Obsolescence of Series SPD73 / Last Time Buy Notification

Description of Change: API Delevan announces the end of life for Product Series SPD73.

Product Classification: Shielded Power Surface Mount

SPD73

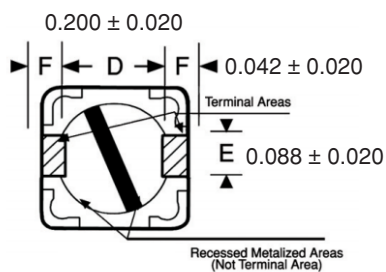
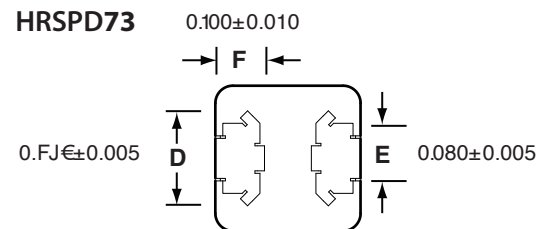
Expected Impact on Form / Fit / Function:

SPD73 Height Dimension 'C'
0.153 Inches Max (3.9 mm Max)

SPD73 Terminal Dimensions
0.088 ± 0.020 'E' (in) by 0.042 ± 0.020 'F' (in)

HRSPD73 Height Dimension 'C'
0.166 Inches Max (4.20 mm Max)

HRSPD73 Terminal Dimensions
0.190 ± 0.005 'D' (in) by 0.100 ± 0.010 'F' (in)
